ZONING AMENDMENT,
PLANNED UNIT DEVELOPMENT &
SUBDIVISION STAFF REPORT

Date: October 4, 2007

<u>NAME</u>	Reid Cummings
<u>SUBDIVISION NAME</u>	Snowden Place Subdivision
<u>LOCATION</u>	North side of Cottage Hill Road, 110'+ East of Christopher Drive East.
<u>CITY COUNCIL DISTRICT</u>	District 6
<u>PRESENT ZONING</u>	R-1, Single-Family Residential and R-3, Multiple-Family
<u>PROPOSED ZONING</u>	R-1, Single-Family Residential and R-3, Multiple-Family
<u>AREA OF PROPERTY</u>	16 Lots / 13.3 \pm Acres (Subdivision and PUD site) 1 Lot / 10.4 \pm Acres (Rezoning site)
<u>CONTEMPLATED USE</u>	<p>Subdivision approval to create 16 lots, Planned Unit Development approval to allow 15 single-family residential lots with reduced front and side setbacks, reduced lot sizes, and increased site coverage, and a 35-unit townhouse condominium complex with multiple buildings on a single building site, in a gated, private street subdivision, and Rezoning from R-1, Single-Family Residential District, to R-3, Multiple-Family Residential District to allow a townhouse condominium complex.</p> <p>It should be noted, however, that any use permitted in the proposed district would be allowed at this location if

SITE PLAN

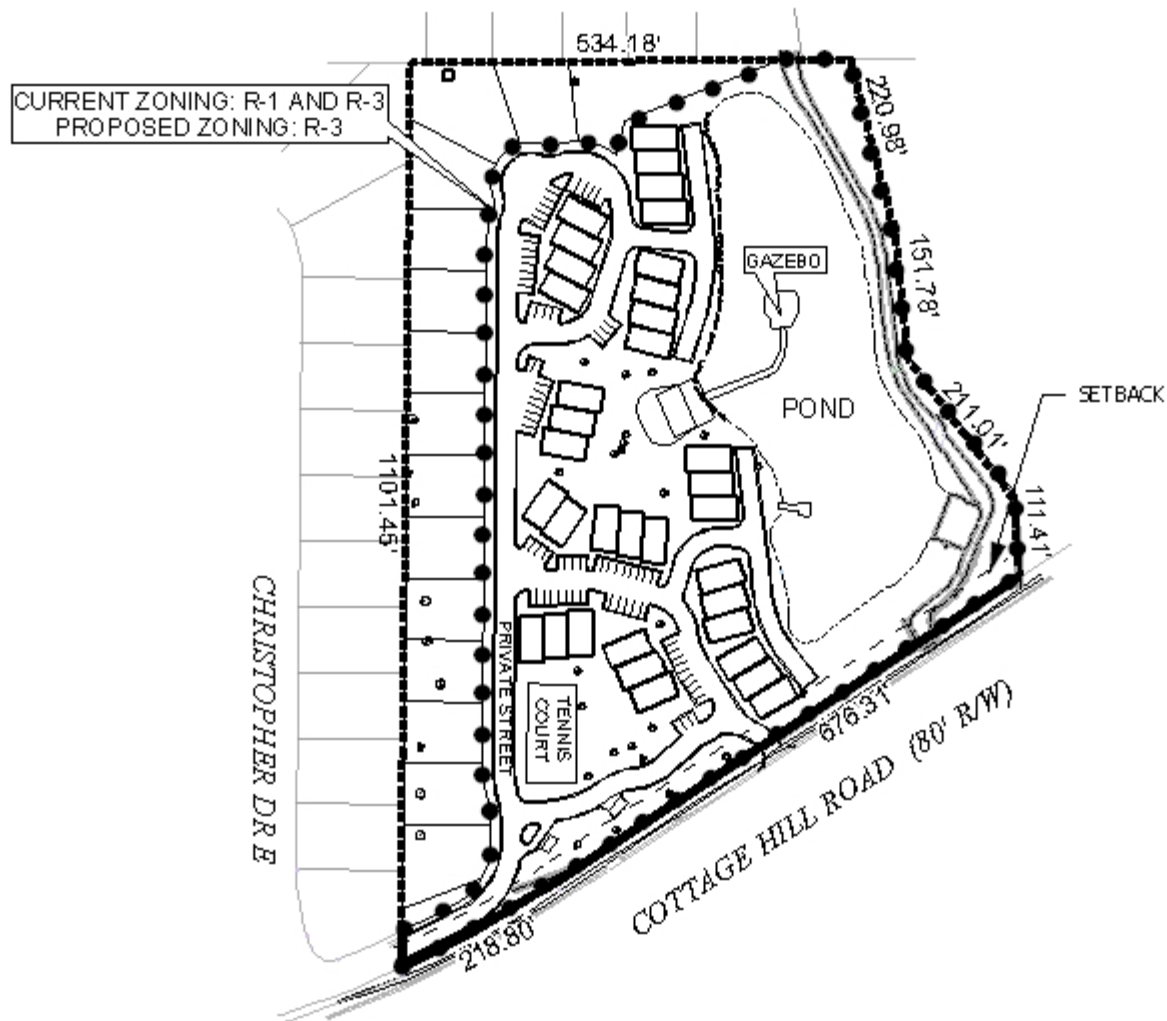
There are several issues of concern regarding the proposed development. As previously mentioned, the minimum building setback line depicted on the subdivision plat, PUD and Zoning site plans is 25-feet from the right-of-way edge of Cottage Hill Road: previous approvals required this setback to be at least 50 feet from Cottage Hill Road so that structures will not be built where a service road may be required at some point in the future. The site plan should be revised to ensure that all buildings meet the setback requirements from all adjacent street frontages, including the additional setback recommended for the service road area.

There is no information on the site plan regarding the height of the proposed condominiums, in terms of number of stories or total height in feet. It is assumed that each townhome will be at least two stories in height due to a garage being proposed for the ground floor.

While residential adjacency buffers are not required, it is recommended that a 6-foot high wooden privacy fence, at minimum, be provided where the condominium development abuts existing single-family development. The fence should be depicted on the PUD site plan.

The existing residence has a large wall along Cottage Hill Road. If the applicant intends to retain the wall, it should be depicted on the site plan.

Access management is a concern due the presence of a major street. As designed, the overall site will have one access onto Cottage Hill Road via proposed Lot 16 and one curb-cut onto the service road on the West side of the site. As previously mentioned, the Subdivision Regulations require that the private street have its own right-of-way, thus the site plan and plat should be revised.

There is no indication on the site plan as to whether the direct entrance onto Cottage Hill will be gated or not. The site plan should be revised to indicate the access status of that entrance. It should also be pointed out that the gated entrance from the service road does not provide any accommodation for turn-around prior to the gate, thus any vehicle not able to gain access to the site will be required to back-up along the service road.

The depicted dumpster pad is within the setback area being requested along Cottage Hill Road. The site plan should be revised to relocate this and the mail box kiosk to be outside of the requested 50-foot setback from Cottage Hill Road.

- 2) Revision of the site plan and plat to depict the minimum building setback lines from all street frontages, to include a 50-foot setback along Cottage Hill Road;

- 3) Revision of the site plan to indicate the number of stories/height of all buildings and dimensioning of the minimum spacing between buildings;
- 4) Consultation with Fire / Rescue to determine if modifications to the site plan are necessary to comply with their regulations, and revision of the site plan as appropriate;

- 6) Depiction and labeling of any required stormwater detention basins;
- 7) Relocation of the dumpster pad, mail box kiosk and any other structures to comply with the 50-foot setback requirement from Cottage Hill Road;

- 8) Provision and depiction of a 6 to 8 foot high privacy fence or wall where the lot containing the condominium portion of the site abuts existing R-1 districts that are developed with single-family residences;

- 11) Placement of a note on the plat and site plan indicating requested site coverage for Lot 16, the proposed R-3 lot;
- 12) Indication on the site plan as to whether or not the entrance onto Cottage Hill Road will be gated;
